Project	IEEE 802.16 Broadband Wireless Access Working Group <http: 16="" ieee802.org=""></http:>			
Title	R-FCH for Relay Zone			
Date	2007-04-16			
Submitted				
Source(s)	Kanchei (Ken) Loa, Yi-Hsueh Tsai, Voice: +886-2-2739-9616			
	Yung-Ting Lee, Hua-Chiang Yin, loa@iii.org.tw			
	Shiann-Tsong Sheu, Youn-Tai Lee,			
	Frank C.D. Tsai, Chih-Chiang Hsieh,			
	Heng-Iang Hsu			
	Institute for Information Industry			
	8F., No. 218, Sec. 2, Dunhua S. Rd.,			
	Taipei City, Taiwan.			
	[add co-authors here]			
Re:	IEEE 802.16j-07/013: "Call for Technical Comments Regarding IEEE Project 802.16j"			
Abstract	This contribution provides R-FCH			
Purpose	Text proposal for 802.16j Baseline Document			
Notice	This document has been prepared to assist IEEE 802.16. It is offered as a basis for discussion			
	and is not binding on the contributing individual(s) or organization(s). The material in this			
	document is subject to change in form and content after further study. The contributor(s)

### **R-FCH for Relay Zone**

Figure 3c R-FCH subchannel allocation for FUSC or AMC zone
OFDMA symbol index

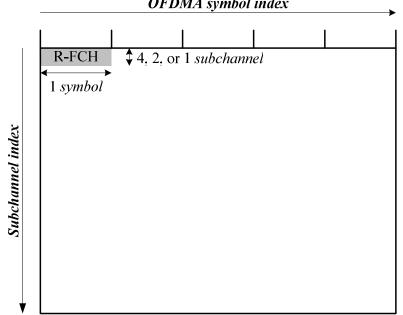
In IEEE 802.16j-026r3, there are three issues in section 8.4.4.7.3 R-FCH channel:

- (1) The subchannel allocation of R-FCH in RS\_Zone with FUSC or AMC permutation is not defined
- (2) FEC Code type and modulation type is not flexible enough, DIUC is used instead.
- (3) RS-Zone prefix format for 128 FFT is not defined whose length is only 12 bits.

If RS\_Zone is FUSC or AMC permutation, the R-FCH shall be allocated as follows. For FFT sizes other than 128, the first 4 slots in the downlink part of subchannel contain the R-FCH. These slots contain 48 bits modulated by QPSK with coding rate 1/2 and repetition coding of 4. For FFT-128, the first slot in the downlink part of the subchannel is dedicated to R-FCH and repetition is not applied. Figure 3d depicts this structure.

If a DL RS\_Zone contains a R-FCH channel, the R-FCH channel shall be transmitted as FCH described in 8.4.4.2. The R-FCH contains the RS-Zone Prefix as described in 8.4.4.7.4. In case that RS\_Zone is PUSC permutation, the subchannel of R-FCH shall be allocated as FCH described in 8.4.4.4. In case that RS\_Zone is FUSC or AMC permutation, the first 4 slots in the downlink part of subchannel contain the R-FCH for FFT sizes other than 128. The first slot in the downlink part of the subchannel is dedicated to R-FCH for FFT-128.
